Wisconsin Electric POWER COMPANY
231 W. MICHIGAN, P.O. BOX 2046, MILWAUKEE, WI 53201

November 16, 1978

DOCKET NOS. 50-266 AND 50-301
REVISION TO HEATUP AND COOLDOWN CURVES
TECHNICAL SPECIFICATION CHANGE REQUEST NO. 57
POINT BEACH NUCLEAR PLANT UNITS 1 AND 2

FIGURE 15.3.1-1

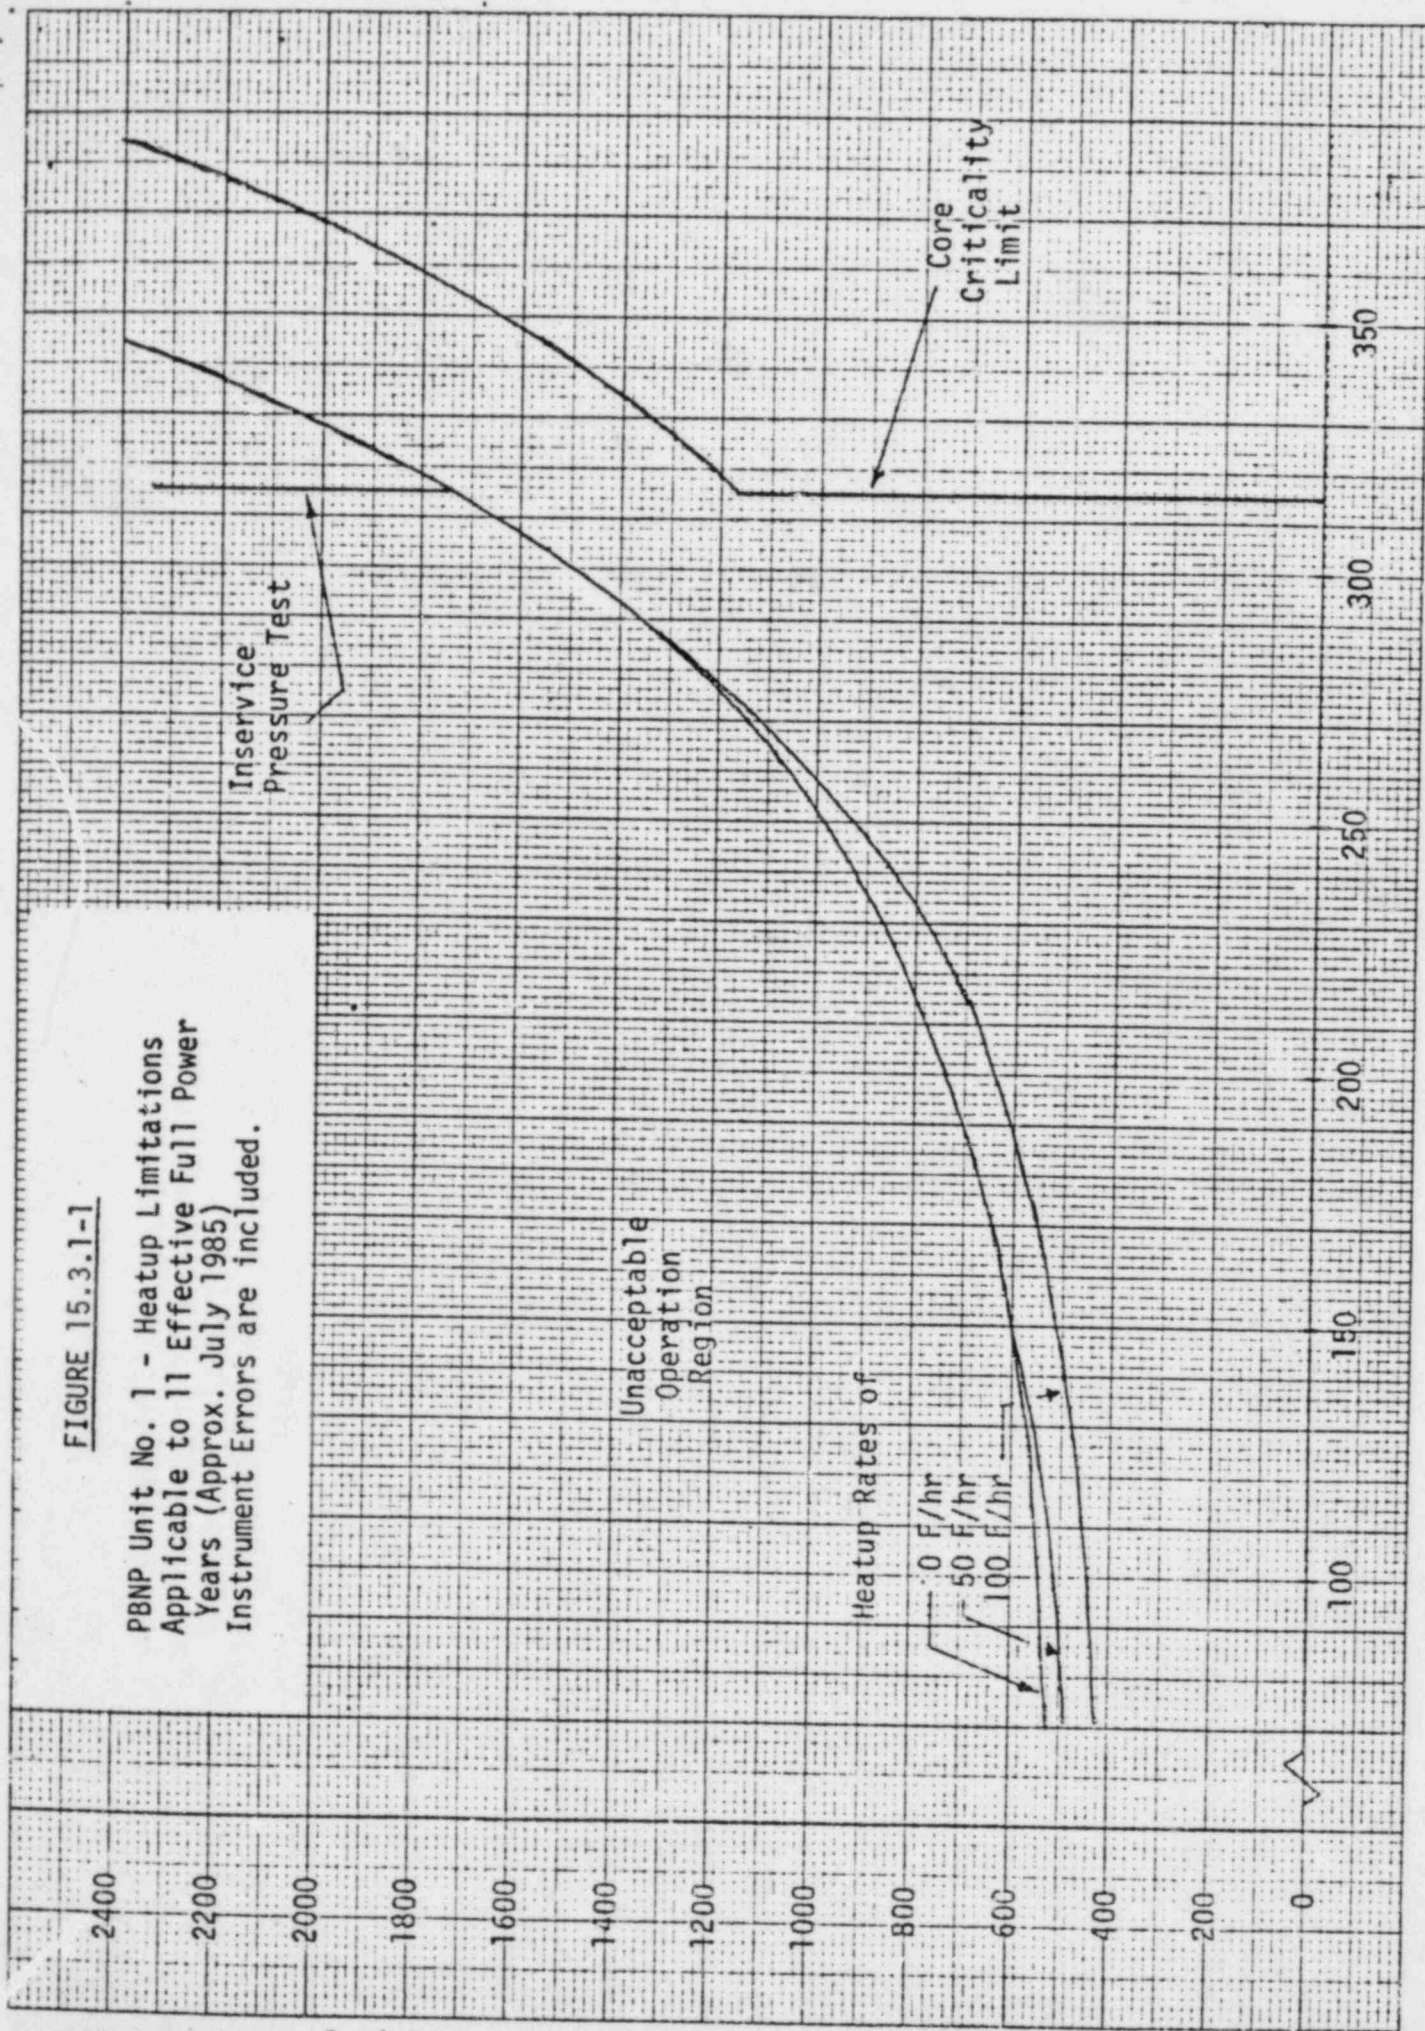
Licensee would also take this opportunity to extend the period of applicability for the present Point Beach Unit 1 heatup and cooldown limitation figures, 15.3.1-1 and 15.3.1-2. As discussed in my letter dated October 1, 1976, the present Unit 1 and Unit 2 heatup and cooldown limitation figures were developed based on the data and methods in Westinghouse Topical Reports WCAP-8743 and -8738 respectively. We noted that these reports were still in draft form at that time and that we would submit these reports, along with the balance of our Appendix G compliance program results, as soon as they were fully reviewed, approved and released. This was done with my letter to Mr. Rusche of March 4, 1977. We have determined, using the methods in WCAP-8743 as provided to the NRC, that the present Unit 1 heatup and cooldown limit curves, namely figures 15.3.1-1 and 15.3.1-2, are applicable up to eleven EFPY. We would therefore request that the period of applicability of these figures be revised from seven EFPY to eleven EFPY. We predict that Point Beach Unit 1 will reach eleven EFPY of reactor vessel exposure in July 1985.

PBNP Unit No. 1 - Heatup Limitations
Applicable to 11 Effective Full Power
Years (Approx. July 1985)
Instrument Errors are included.

FIGURE 15.3.1-4

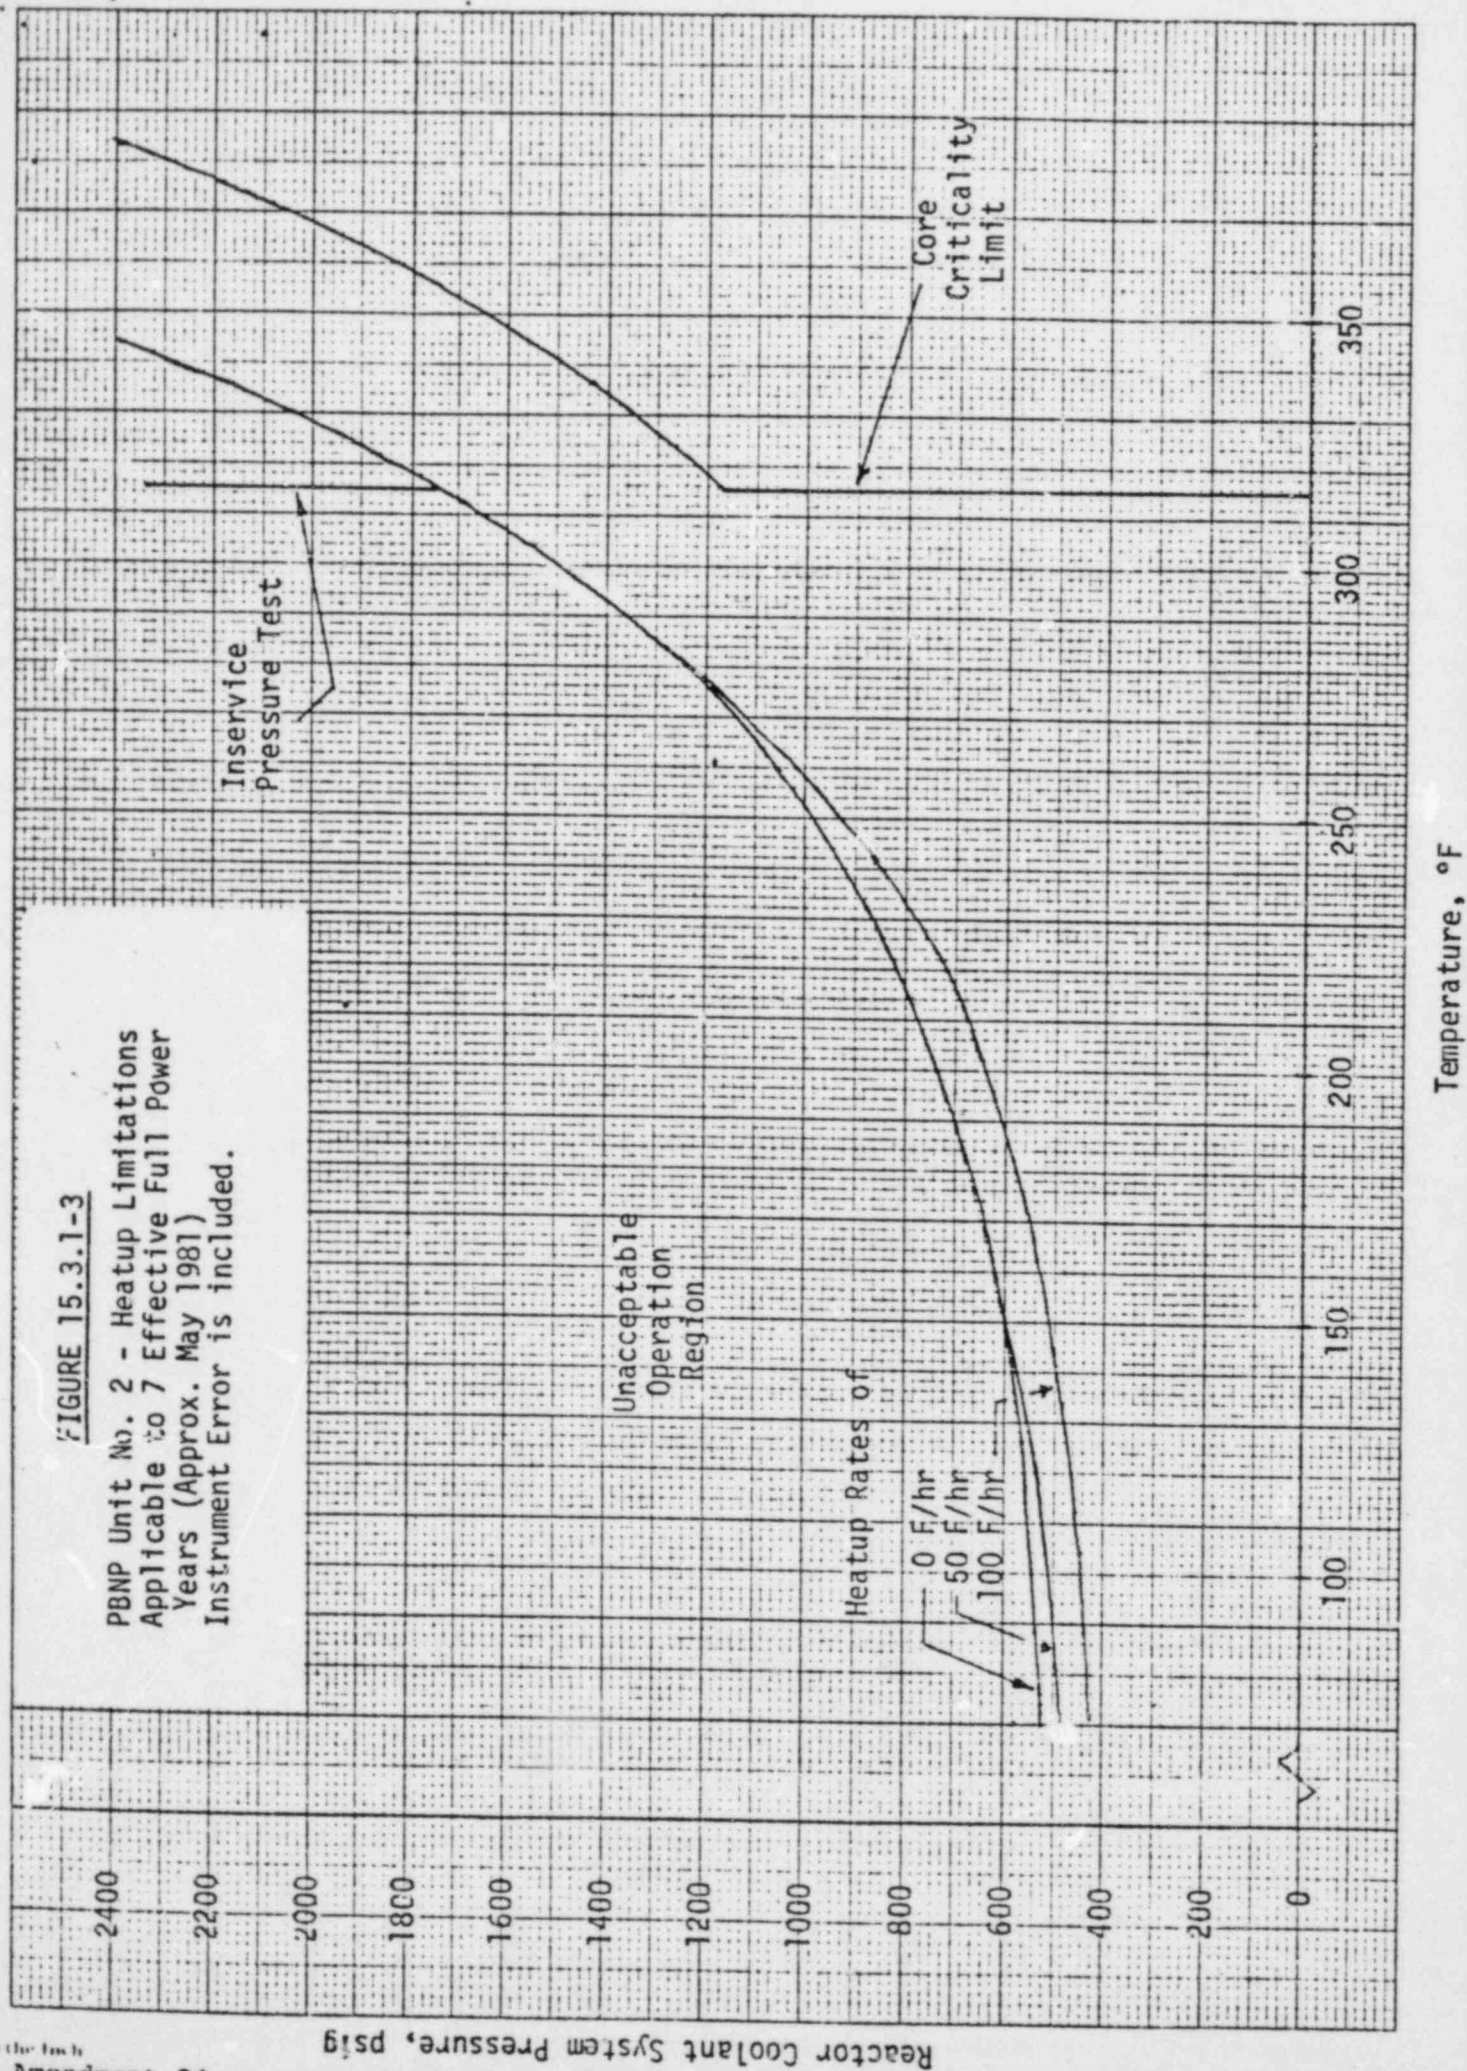
Technical Specification 15.3.1.B.4 requires that revised reactor coolant system temperature and pressure limit figures shall be submitted to the Commission at least 60 days before the calculated exposure of the applicable reactor vessel exceeds the exposure for which the figures apply. The present figures for Unit 2, 15.3.1-3 and 15.3.1-4, are applicable to five effective full power years (EFPY) of operation. It is predicted that Unit 2 will reach five EFPY of operation in January 1979. Therefore, we are providing herewith revised heatup and cooldown limitation figures for Point Beach Unit 2 extended to seven EFPY. It is estimated that this revision would extend the applicability of these figures through May 1981. These curves were developed using methods and data provided in Westinghouse Topical Report WCAP-8738.

You will notice that although the periods of applicability are different, the heatup and cooldown curves proposed herein for both units are essentially identical. The results of chemical analysis of the reactor vessel weld metals showed that the copper content of the Unit 2 weld metal is higher than that of the Unit 1 vessel. As a result of this, for any given vessel exposure, the correct ΔRT_{NDT} versus fluence prediction (0.25% Copper Base, 0.20% Weld line for Unit 1 and the 0.30% Copper Base, 0.25% Weld line for Unit 2) will show a larger ΔRT_{NDT} shift for Unit 2 than for Unit 1. In the case of the attached curves, the ΔRT_{NDT} shift for each unit is the same, hence the period of applicability for Unit 2 must be less than Unit 1.

PBNP Unit No. 2 - Cooldown Limitations
Applicable to 7 Effective Full Power
Years (Approx. May 1981)
Instrument Error is included.
